## WSR 23-15-015

## EXPEDITED RULES

Purpose of the Proposal and Its Anticipated Effects, Including Any Changes in Existing Rules: Reconciling state amendments with section renumbering and model code modifications in the 2021 IRC; correcting errors and omissions.

Figure R403.1.1(1)  
 Alternative Minimum Footing Size for Light-Frame Construction  
 a, b, c, d, e, f, g, h, i  
 20 PSF Snow Load

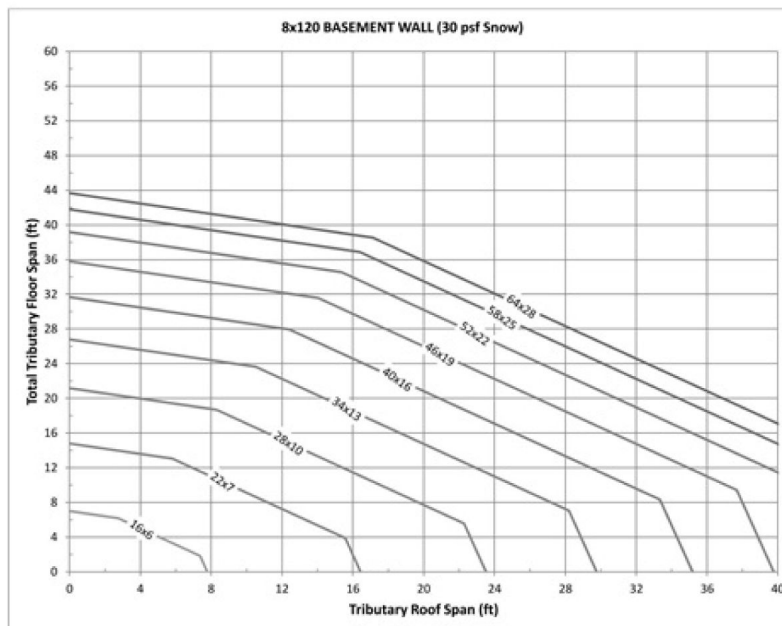
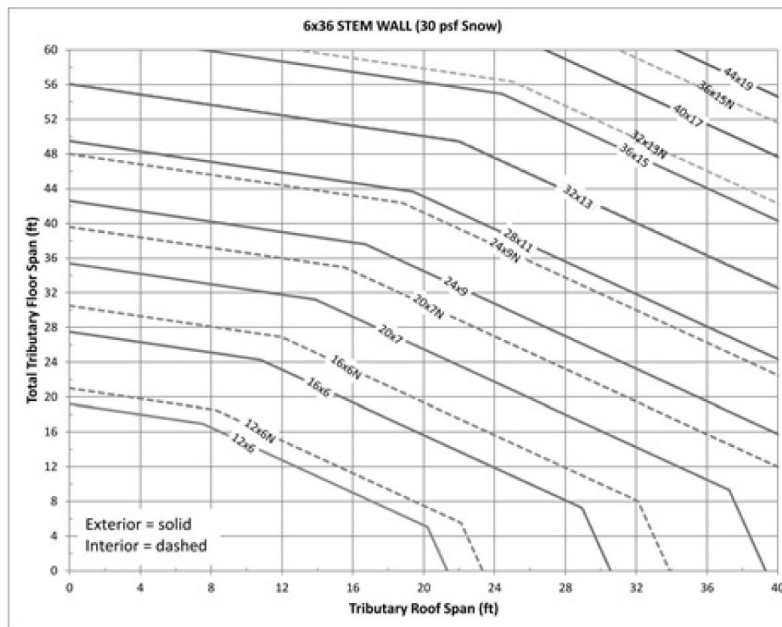
WAC	Section	Change	Rationale/Discussion
51-51-0403	Figure R403.1.1 (1), R403.1.1 (2), R403.1.1 (3), R403.1.1 (4) footnote c.	Spells out feet.	Editorial modifications with no change in regulatory effect; intended to align the state amendment with the model code language.
51-51-0408	R408.1	Replaces the word "six" with the number "6" and adds a metric measurement (152 mm) for six inches.	Editorial modifications with no change in regulatory effect; intended to align the state amendment with the model code language.
	R408.1 Exception	Replaces the word "two" with the number "2" and adds a metric measurement (51 mm) for two inches.	
51-51-0507	Table 507.3.1	<ul style="list-style-type: none"> <li>Identifying the applicable cells for the footnotes.</li> <li>Editorial modifications.</li> </ul>	Editorial modifications with no change in regulatory effect; intended to align the state amendment with the model code language.

- b Use tributary span of floor and roof. Figure may be used to size exterior and interior footings.
  - c Add 4 feet to tributary floor span for each wood-framed wall above first level (i.e., ((4')) 4 feet for 2-story, ((8')) 8 feet for 3-story).

Figure R403.1.1(2)  
 Alternative Minimum Footing Size for Light-Frame Construction  
 a, b, c, d, e, f, g, h, i  
 30 PSF Snow Load

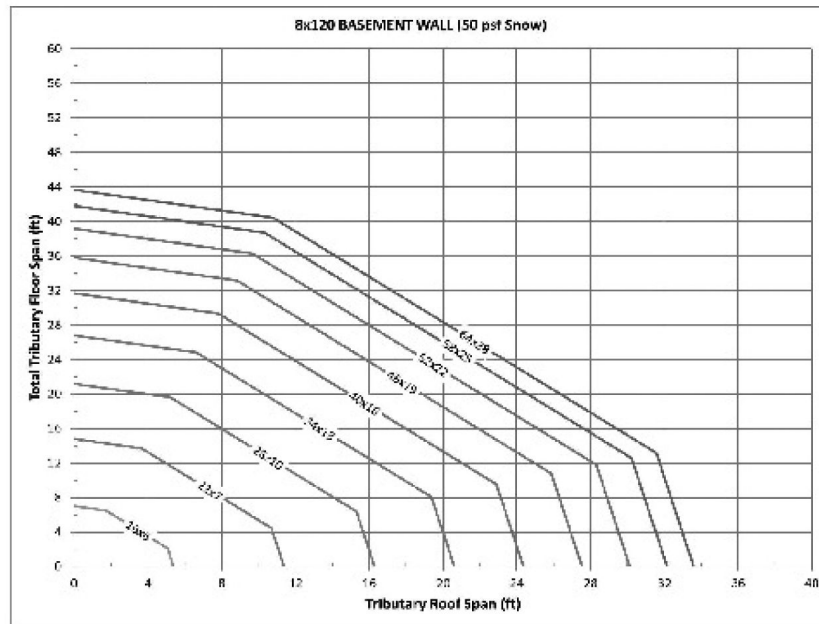
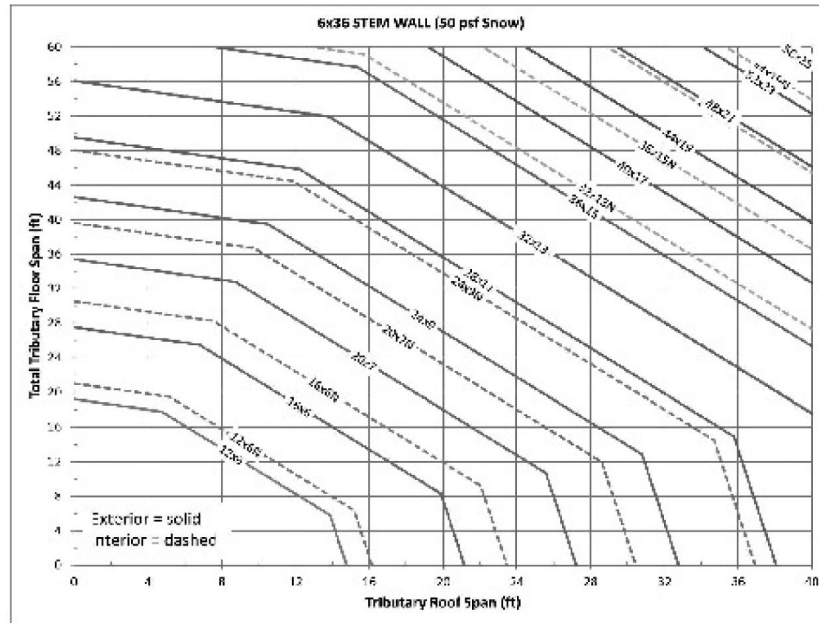
- b Use tributary span of floor and roof. Figure may be used to size exterior and interior footings.
  - c Add 4 feet to tributary floor span for each wood-framed wall above first level (i.e., ((4')) 4 feet for 2-story, ((8')) 8 feet for 3-story).

Figure R403.1.1(3)  
 Alternative Minimum Footing Size for Light-Frame Construction  
 a, b, c, d, e, f, g, h, i  
 50 PSF Snow Load

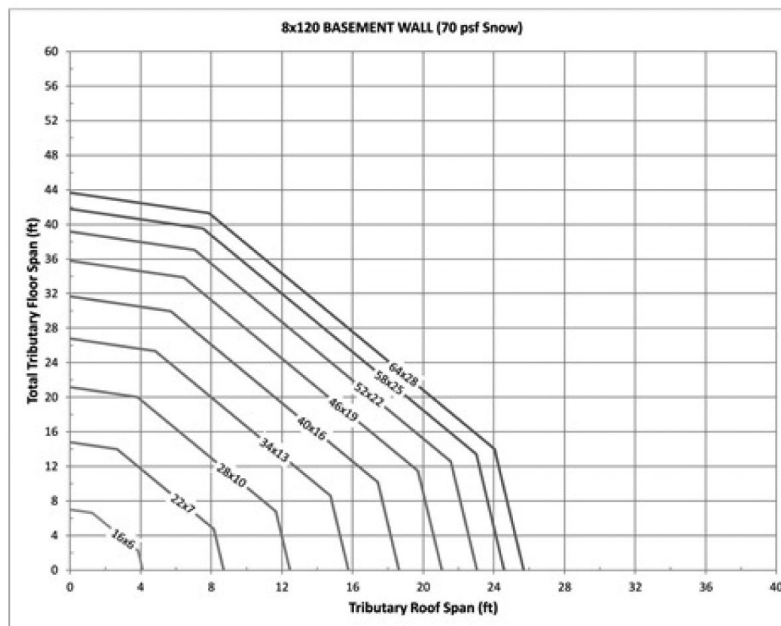
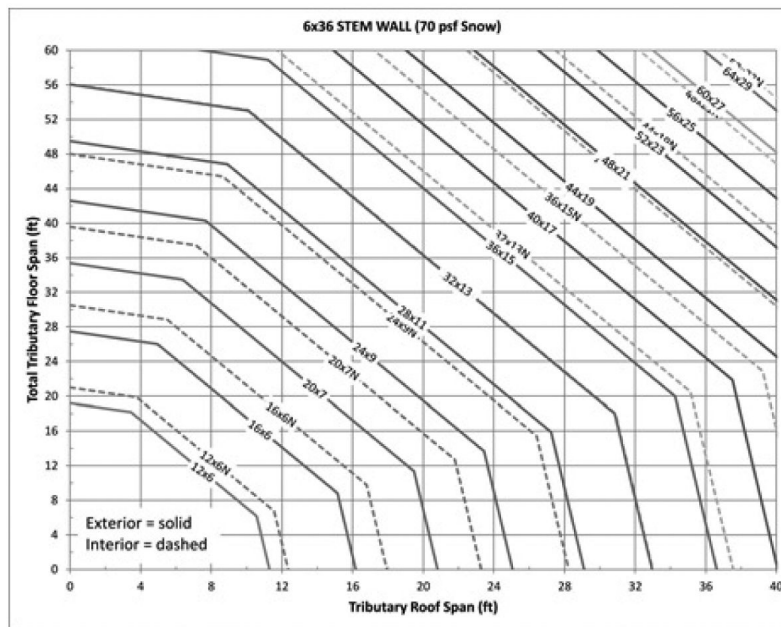
- b Use tributary span of floor and roof. Figure may be used to size exterior and interior footings.
  - c Add 4 feet to tributary floor span for each wood-framed wall above first level (i.e., ((4')) 4 feet for 2-story, ((8')) 8 feet for 3-story).
